Revision Summary:

Site 68
Sydney Olympic Park
South-East

A05.01[03]

Approved Roof Profile

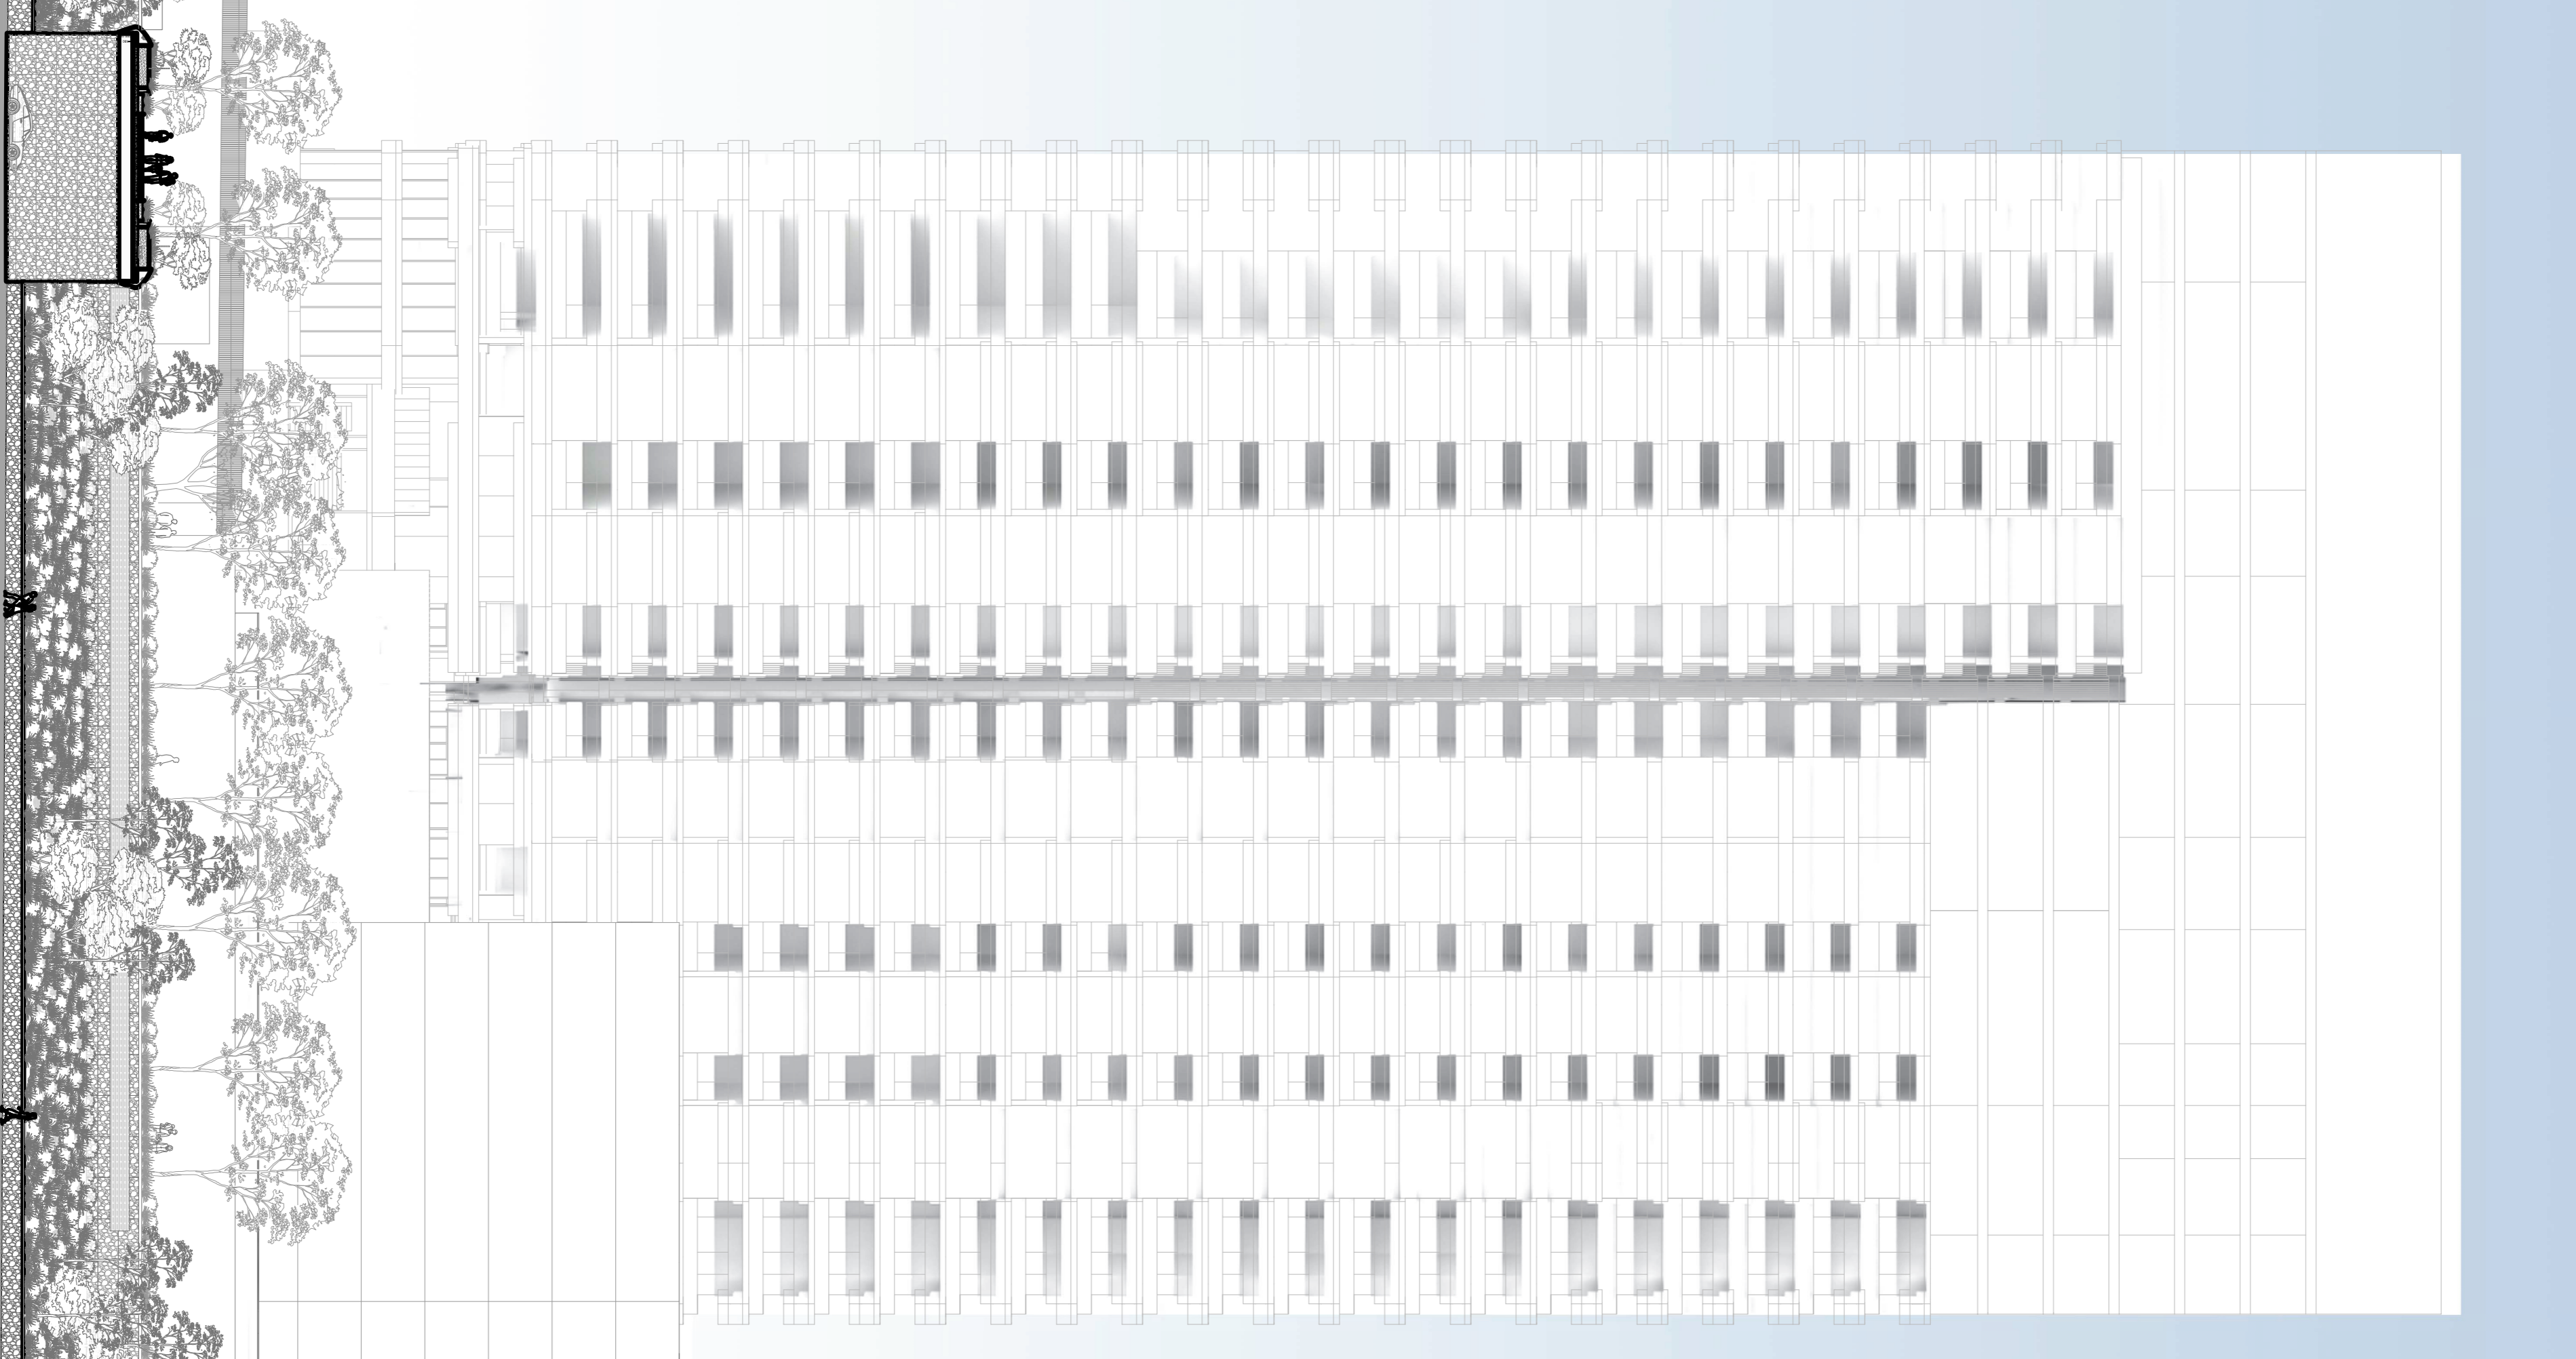
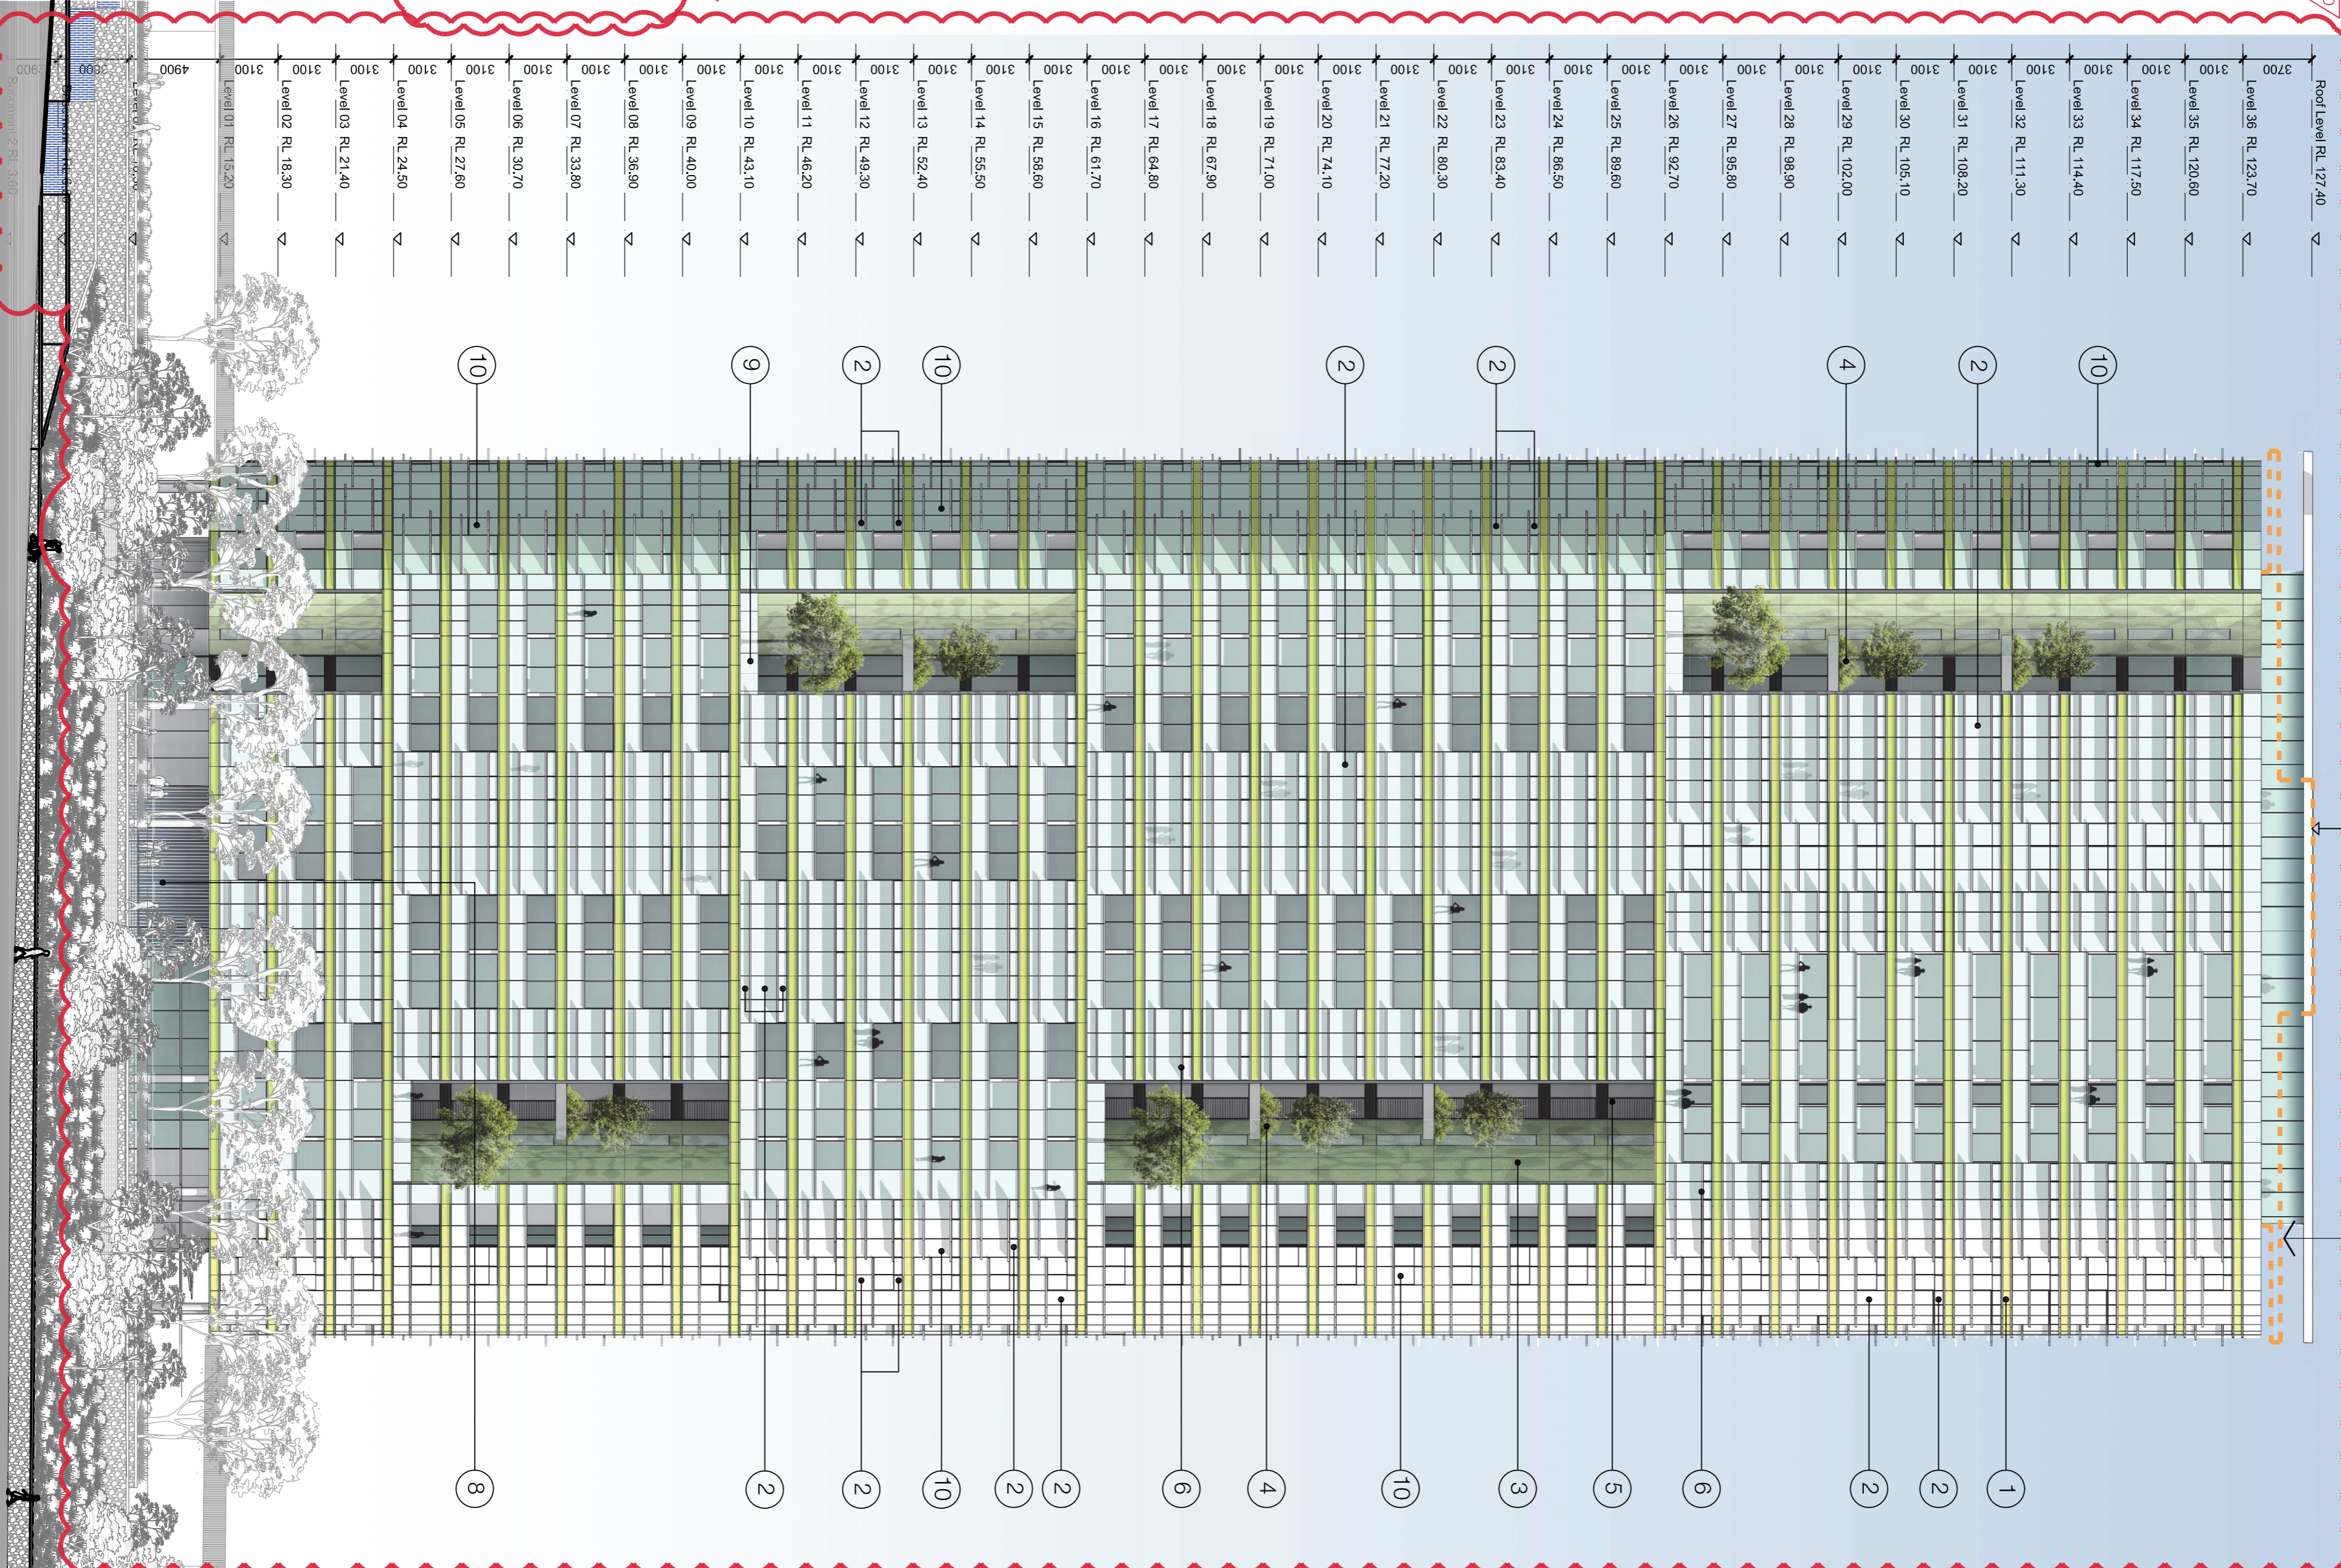
RL 127.40
(unchanged from approved)

- Revision 03 - Section 96 Amendments
 - A - Revisions to landscape levels, lower lobby fit, lowered from 0.0/0 to 3.1m, lower signal base to base height base, reduce from 5.5m to 3.1m.
 - B - Excess plant space on rooftop converted to residential flats. New floor reserved at level 25.
 - C - Amenity at level 25.
 - D - Amendments to setbacks.
